XP-8X4X-Atom CE6 OS Release Note,

Version 1.0.0.1 [Apr., 09, 2012]

How to determine the BIOS version

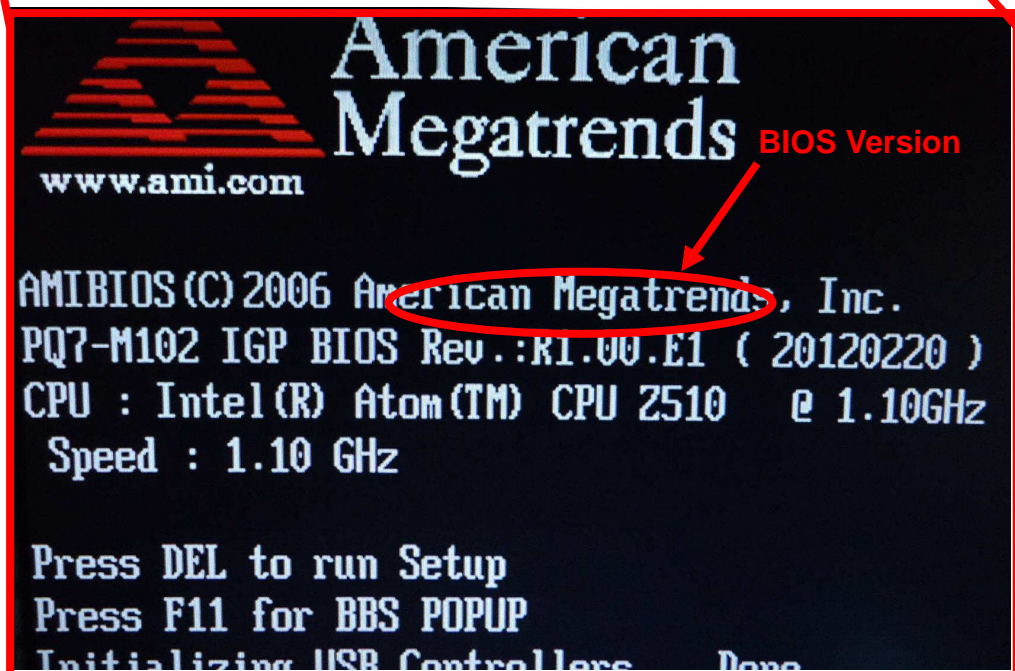
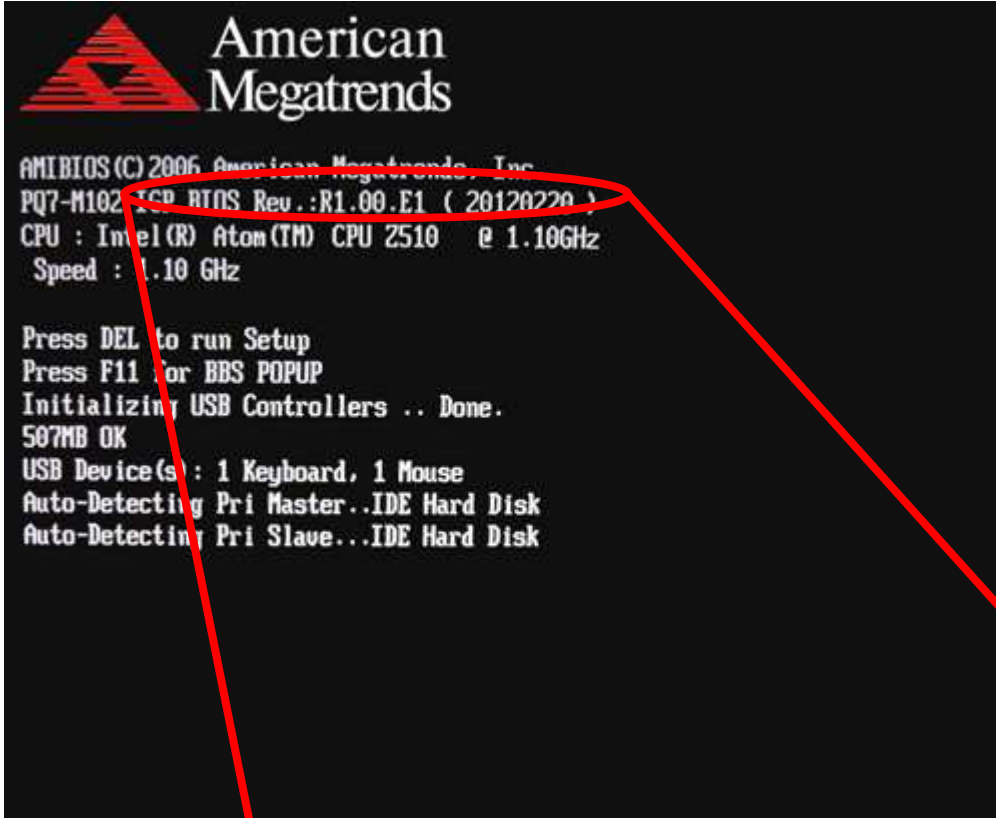
1. Power on the XP-8000-Atom-CE6 and press the "Pause Break" key on your PC keyboard to suspend the boot process.
2. Identify the version as shown below:
